SUBJECT: AMENDMENT NO. 76 TO FACILITY OPERATING LICENSE NO. NPF-30
(TAC NO. M82656)

The amendment revises Technical Specification Section 4.4.9.1.2, Figures 3.4-2, 3.4-3, and 3.4-4, Tables 4.4-5 and B 3/4.4-1 and associated Bases for Reactor Coolant System Pressure/Temperature Limits by modifying plant heatup and cooldown curves and the maximum allowable PORV setpoint curve for cold overpressure protection.

CALLAWAY PLANT, UNIT 1

SAFETY EVALUATION BY THE OFFICE OF NUCLEAR REACTOR REGULATION
RELATED TO AMENDMENT NO. 76 TO FACILITY OPERATING LICENSE NO. NPF-30

FIGURE 3.4-2

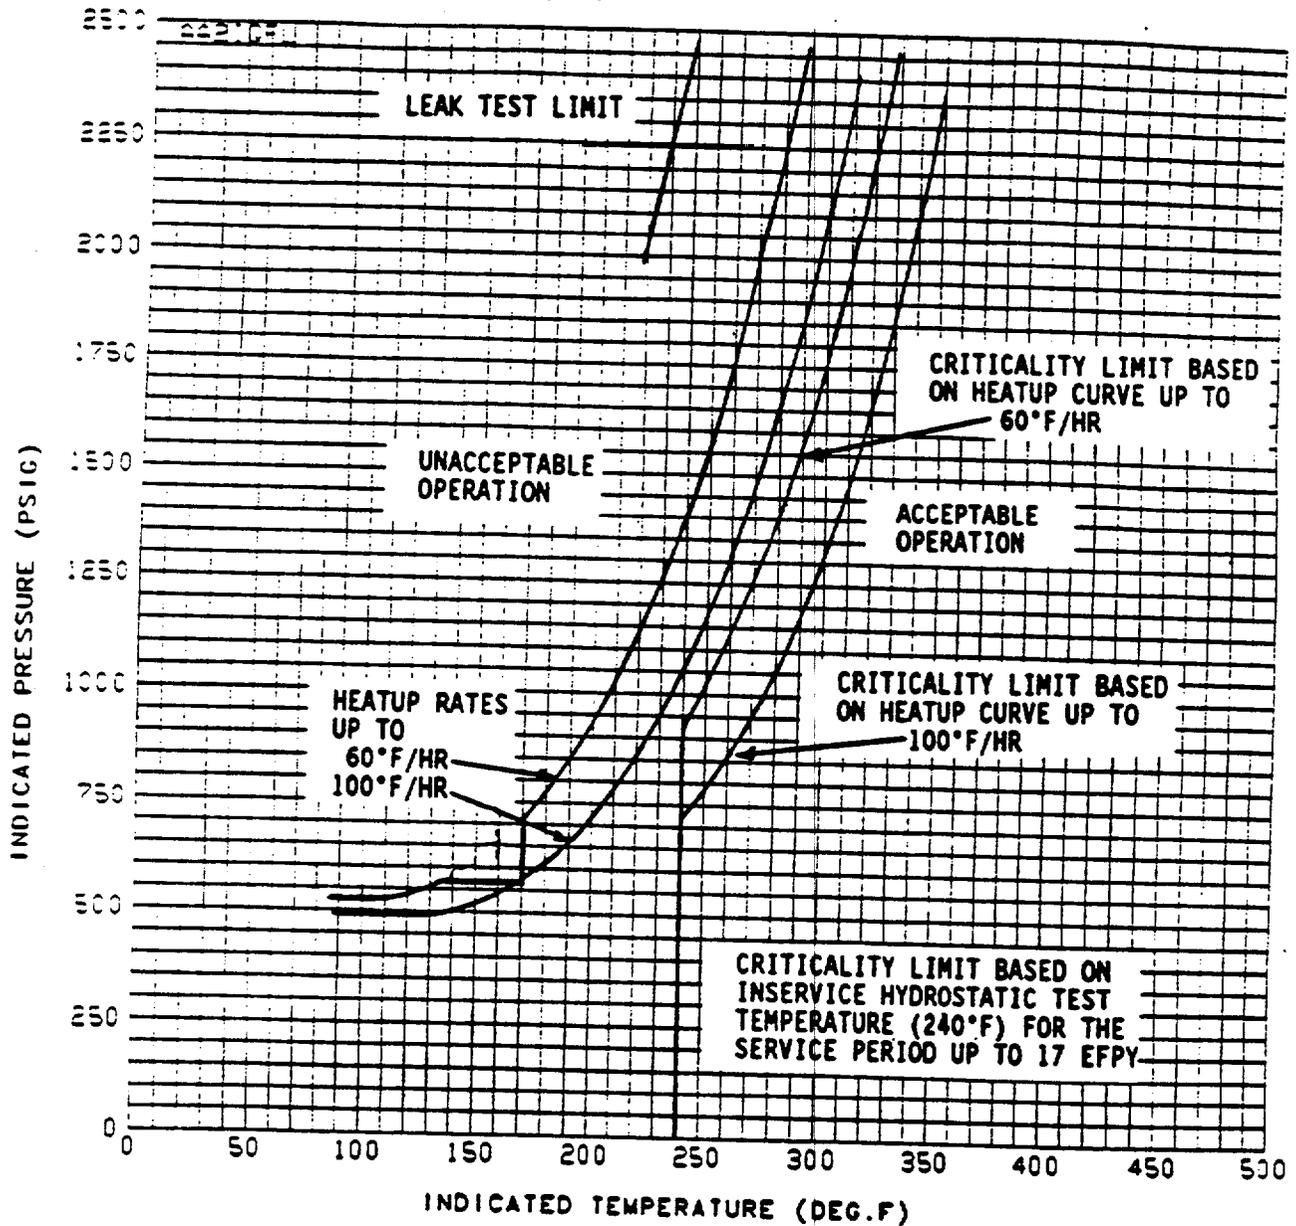
Callaway Unit 1 Reactor Coolant System Heatup Limitations (Heat up rates up to 60°F/hr and 100°F/hr) Applicable for the First 17 EFY (With Margins 10°F and 60 psig For Instrumentation Errors)

The staff evaluated the effect of neutron irradiation embrittlement on each beltline material in the Callaway 1 reactor vessel. The amount of irradiation embrittlement was calculated in accordance with RG 1.99, Rev. 2. The staff has determined that the material with the highest ART at 17 EFPY at 1/4T (T = reactor vessel beltline thickness) was the lower shell plate R2708-3 with 0.07% Cu, 0.59% Ni, and an initial RT_{ndt} of 20°F. The material with the highest ART at 17 EFPY at 3/4T was the lower shell plate R2708-1 with 0.07% copper (Cu), 0.59% nickel (Ni), and an initial RT_{ndt} of 50°F.

The licensee used the method in RG 1.99, Rev. 2, to calculate an ART of 95°F at 17 EFPY at 1/4T for the same limiting plate material. The staff determines that the licensee's ART of 95°F is more conservative than the staff's ART of 94.6°F, and it is acceptable. Substituting the ART of 95°F into equations in SRP 5.3.2, the staff verified that the proposed P/T limits for heatup, cooldown, and hydrotest meet the beltline material requirements in Appendix G of 10 CFR Part 50.

FIGURE 3.4-3

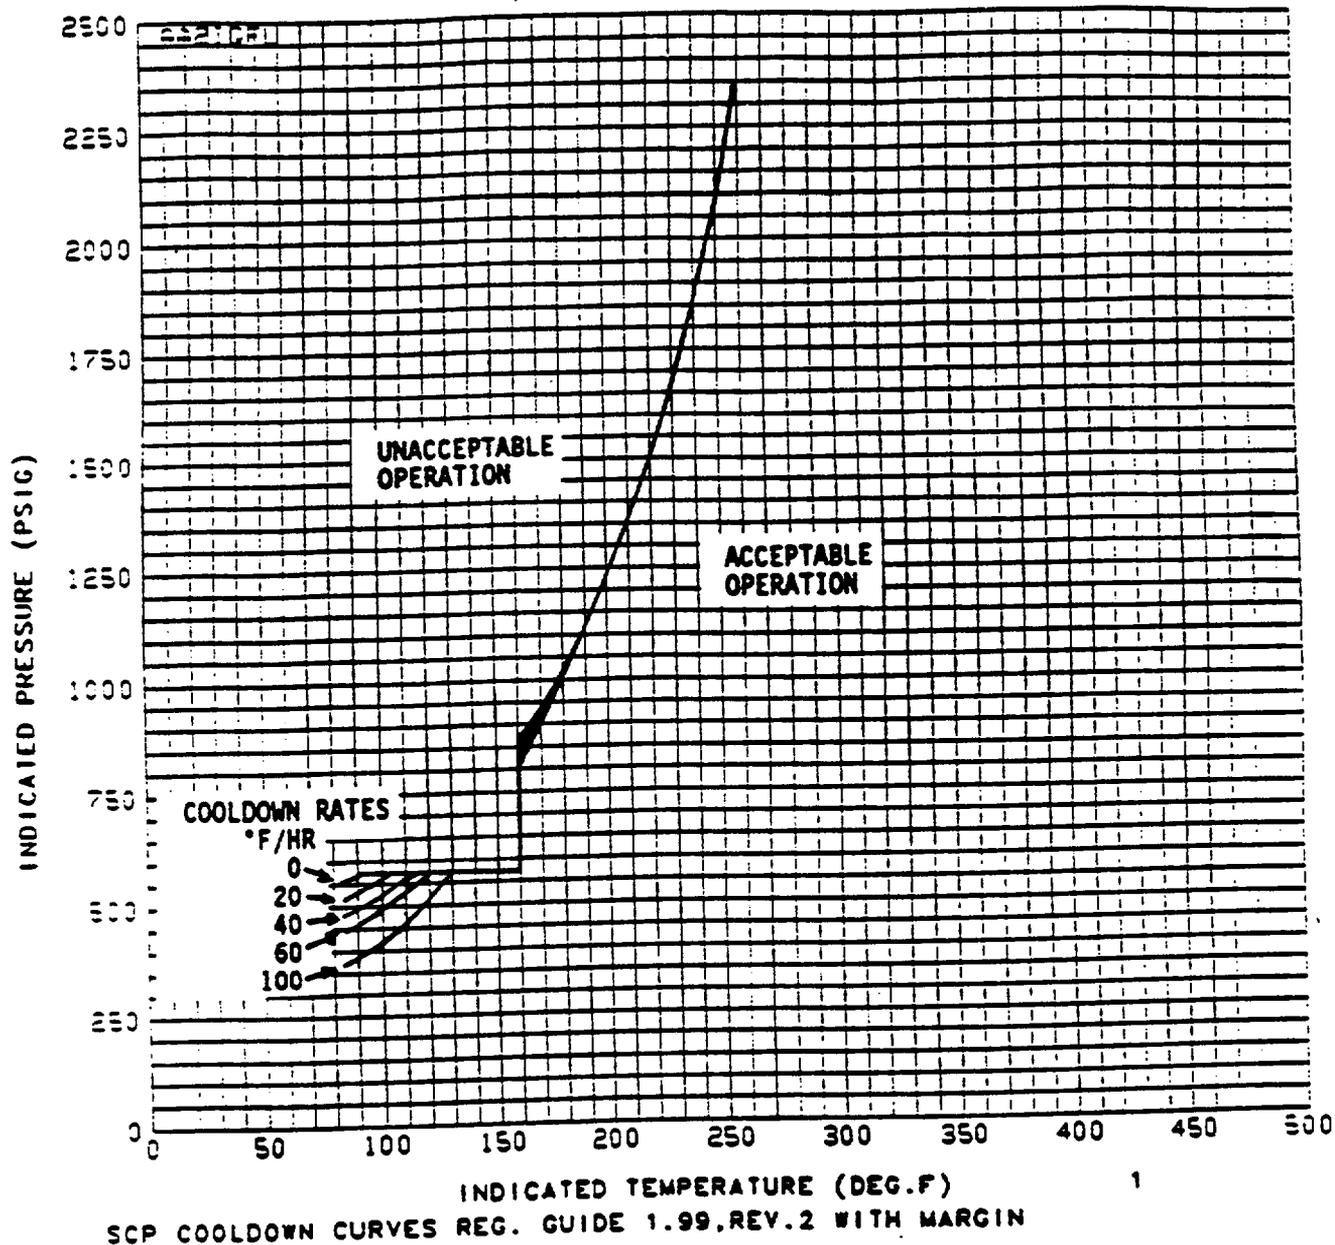
Callaway Unit 1 Reactor Coolant System Cooldown (Cooldown rates up to 100°F/hr) Limitations Applicable for the First 17 EFPY (With Margins 10°F and 60 psig For Instrumentation Errors)

**FIGURE 3.4-4
 MAXIMUM ALLOWED PORV SETPOINT
 FOR THE COLD OVERPRESSURE MITIGATION SYSTEM**

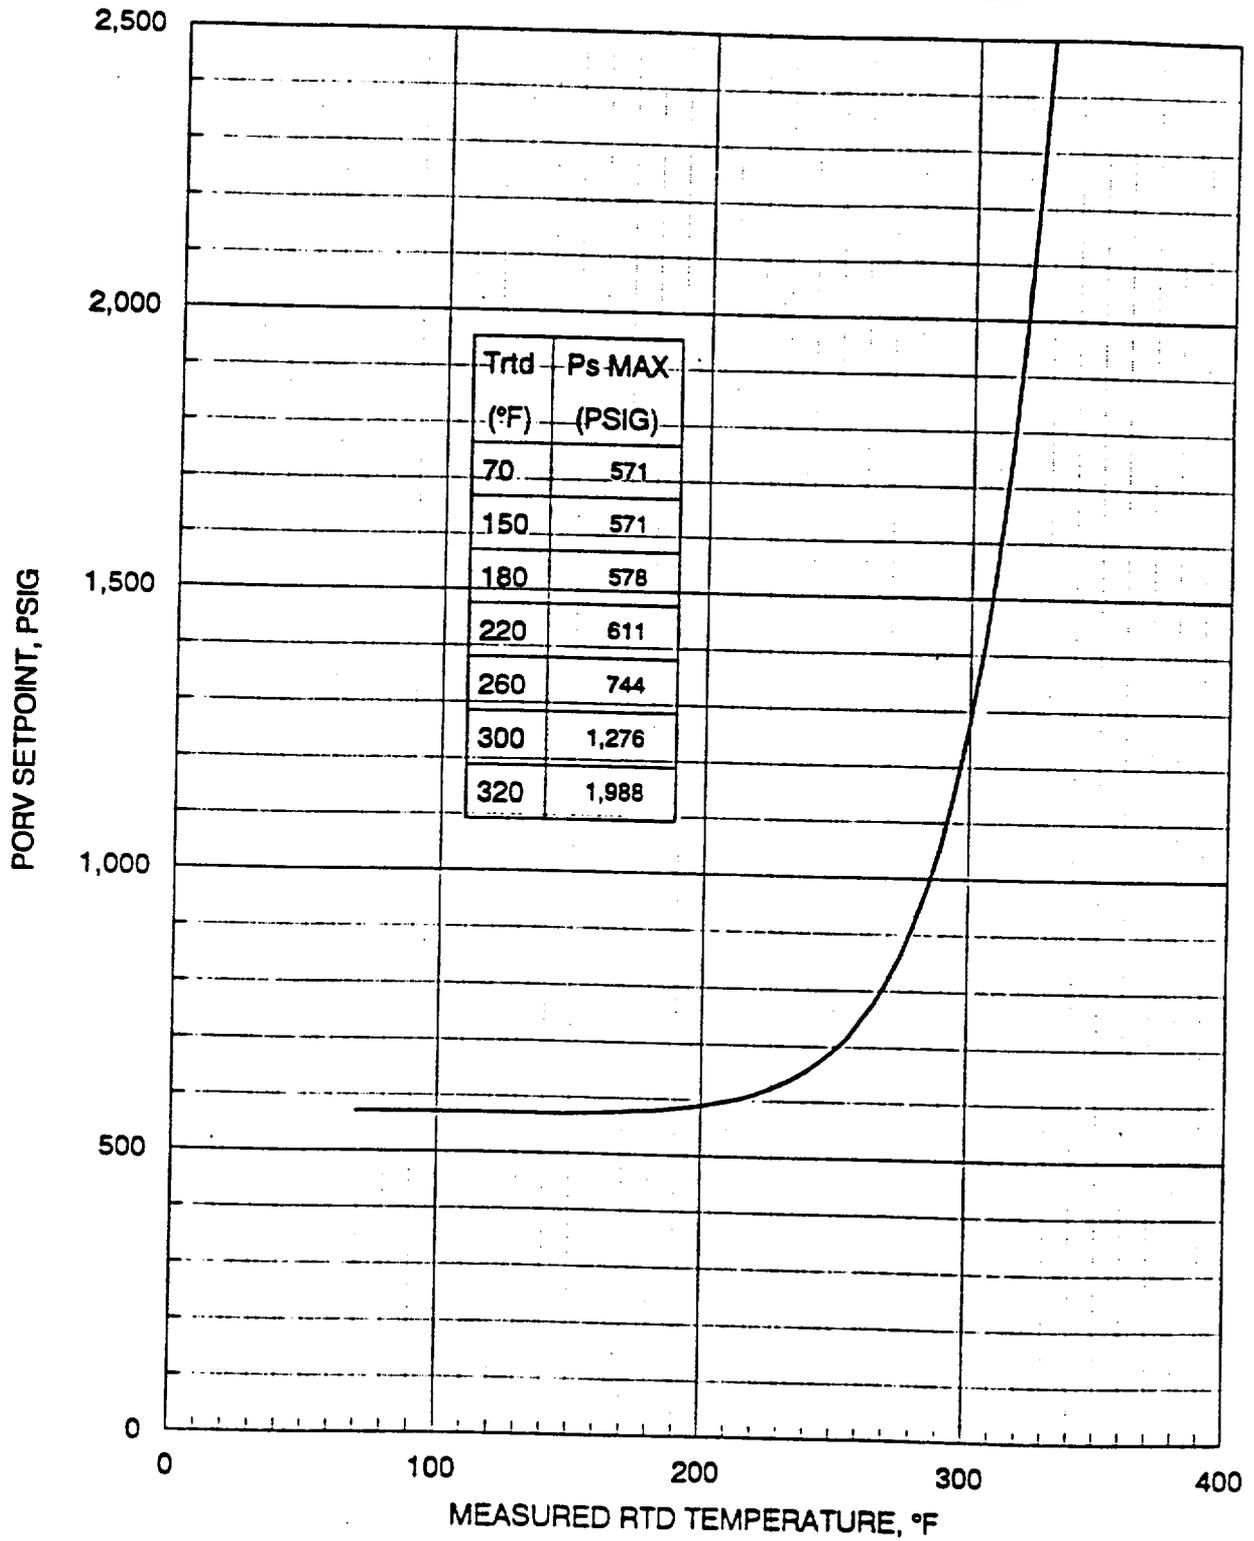
The Maximum Allowed PORV setpoint for the Cold Overpressure Mitigation System will be updated based on the results of examinations of reactor vessel material irradiation surveillance specimens performed as required by 10 CFR Part 50, Appendix H.
